SERVICE BULLETIN

REVISION NO. 3, DATED 2004/02/03

Bulletin No. 60-703-28-35
Revision 3, 2004/02/03
H/A 8-160
ATA 28-31

FUEL – MODIFICATION OF FUEL OVERRIDE JETTISON PUMP MOTOR-IMPELLER SUBASSEMBLIES P/N 60-70303, 60-70306, 60-70307, 60-70308, 60-70309, 60-703103, 60-703104, 60-703113, (BPN 60B92603-3, -7, -9, -10, -11, -13, -14, -15) TO P/N 60-70303-3, 60-70306-3, 60-70307-3, 60-70308-3, 60-70309-3, 60-703103-3, 60-703104, 60-703113-3 (BPN 60B92603-303, -307, -309, -310, -311, -313, -314, -315).

**Inlet Impeller-to-Inlet Adaptor Clearance
Figure 1**

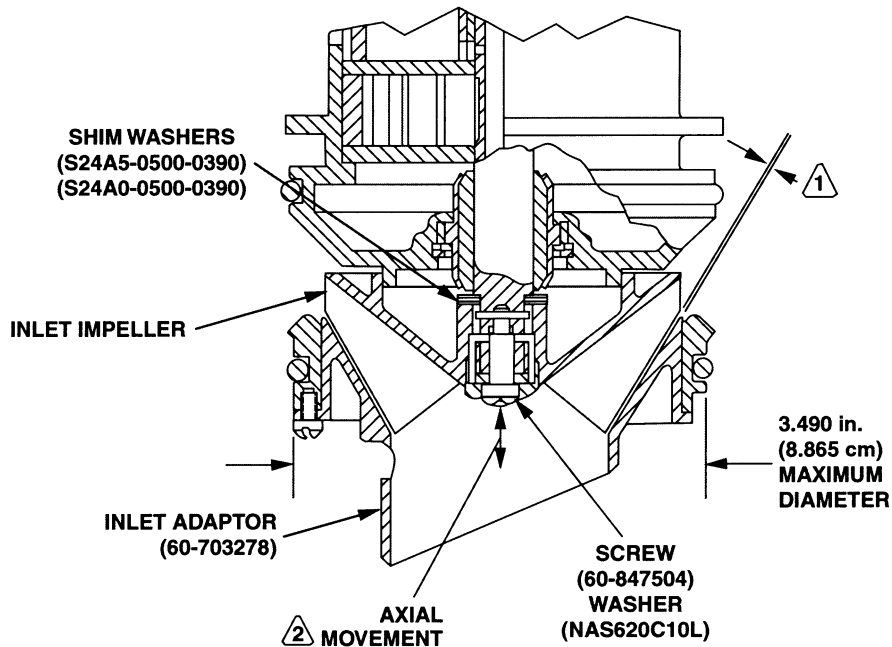
Cavitation wear of the inlet adapter has been occurring due to the vibration of the inlet check valve flapper in the fuel stream. Excessive wear on the inlet adapter may affect pump performance and will eventually lead to the failure of the inlet check valve assembly.

This service bulletin gives instructions for the modification of Hydro-Aire Fuel Override/Jettison Pump Motor-Impeller Subassembly configurations shown in paragraph 1.A. The resulting -3 configurations will include a new Stellite-coated inlet adapter.

- (C) Attach a new Stellite-coated inlet adapter, P/N 60-703278, with three new washers, P/N NA620C4, and screws, P/N MS35275-213, to the inner housing using finger-tight torque on the screws. **DO NOT TORQUE SCREWS AT THIS TIME.**

- (E) Move the inlet impeller in and out and note the axial movement. Total axial movement must be 0.001–0.008 inch (0.003–0.020 cm).

- (F) Measure the clearance between the inlet impeller and inlet adapter by inserting a feeler gauge with a width of 0.200 inch (05.08 cm) or less and a thickness of 0.007–0.010 inch (0.018–0.025 cm) between the two parts.

NOTE: Clearance between the inlet impeller and inlet adapter must be 0.007 to 0.010 inch (0.018–0.025 cm). Add or remove shim washers, S24A5-0500-0390 or S24A0-0500-0390, to get the required clearance. The ratio of clearance to washers is 1:2. That is, a 0.001-inch difference in clearance requires a 0.002-inch change in shim washers.

① 0.007 – 0.010 in (0.018 – 0.025 cm) CLEARANCE.

② 0.001 – 0.008 in (0.003 – 0.020 cm) AXIAL MOVEMENT BEFORE AND AFTER TEST.

NOTE: Be sure that safety wire does not extend beyond the 3.490-inch (8.865-cm) maximum diameter, as shown in Figure 1.
